Planning Commission Staff Report

Project Type: Site Development Section Plan

Meeting Date: February 13, 2017

Description: **Trails West Village of Greentrails, Lot 270 B:** A Site Development Section Plan, Landscape Plan, Lighting Plan, Architectural Elevations and an Architect's Statement of Design for a 3.6 acre tract of land zoned "C-8" Planned Commercial District, located at the southeast corner of Ladue Road and Greentrails Drive.

March 2016 Architectural Elevation—Front and Rear Elevations

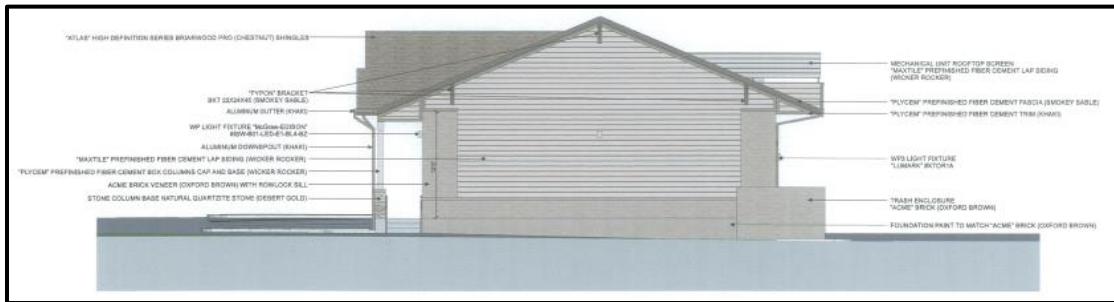
This project was presented to the ARB in March of 2016, where a motion to recommend approval with recommendations was passed. The recommendations primarily pertained to the screening of the roof-mounted mechanical units and lack of residential character in the building design.

Subsequently, the property owner engaged a new Architect and made substantial design revisions in order to incorporate the ARB’s recommendations into the design proposal. The project was then presented for a second time to the ARB in January of 2017. The comparison below shows the original design reviewed by the ARB in March of 2016 and the revised design presented in January of 2017.

The following excerpts from the Architectural Elevations and rendering show the screening unit that was presented at the January 2017 ARB meeting:

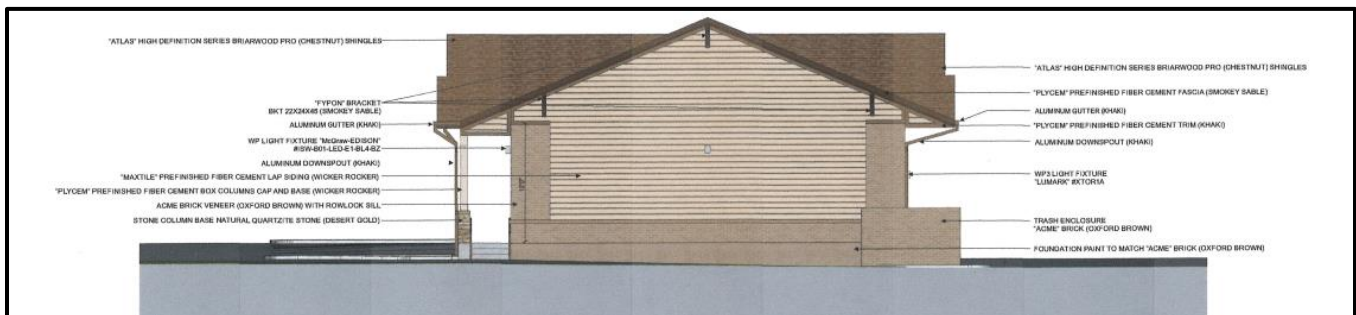
At the January 2017 ARB meeting, the ARB noted that the overall design was substantially improved and incorporated the Board’s recommendations from the March 2016 meeting. However, the ARB did provide additional feedback on the proposed screening unit on the rear of the building and also recommended that the applicant incorporate additional landscape along the northern building elevation.
